1. Comment [r01-462](#) - Updating Figure 145-22 page 168 line 35, Figure 145-31 page 207 line 22 to sync with proposed text in comments [r01-286](#), [r01-287](#).
2. Addressing comment [r01-378](#) regarding the need to split Rsource\_min/max to Rsource1\_min, Rsource2\_min and Rsource1\_max, Rsource2\_max for setting the correct PSE voltage at the PSE PI to allow adjusting Vsource to get VPort\_PSE-2P at the PSI PI. [This comment is addressed in a simpler way.](#)

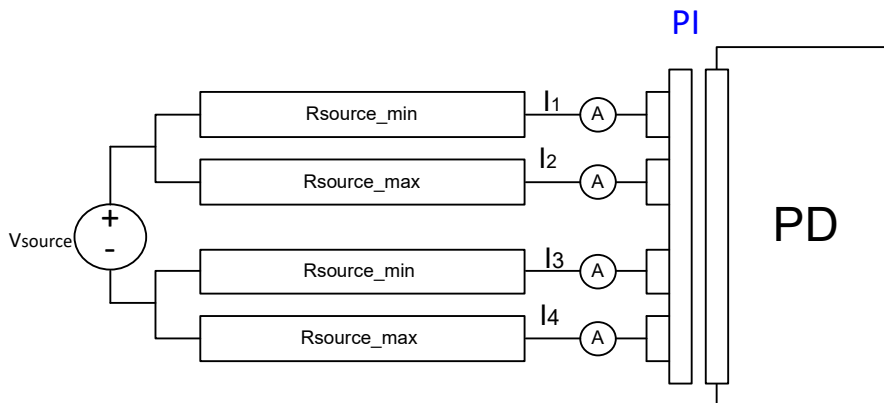
Per the latest changes we did to include equipment connector in the PSE PI and in the PD PI for unbalance tests the following changes should be made:

- a) Figure 145-22, the borders of the test verification model need to be clearly shown.
- b) Figure 145-31 and NOTE 1 in line 33 need similar adjustments.

2. *Change figure 145-31 as follows:*

3. *Change the title of Figure 145-31 from:*

"Figure 145-31—Icon-2P\_unb and lunbalance evaluation model"

To:

"Figure 145-31—PD current unbalance verification circuit"

5. *Delete Note 1* ("OTE 1—Rsource includes the connector resistance at the PD PI, for which the maximum recommended value is 20 mΩ per contact.)

6. *Make the following changes to NOTE 2:*

NOTE 2—The pairset current limits [requirement also holds](#) ~~should also be met~~ when Rsource\_max and Rsource\_min are swapped between pairs of the same polarity.
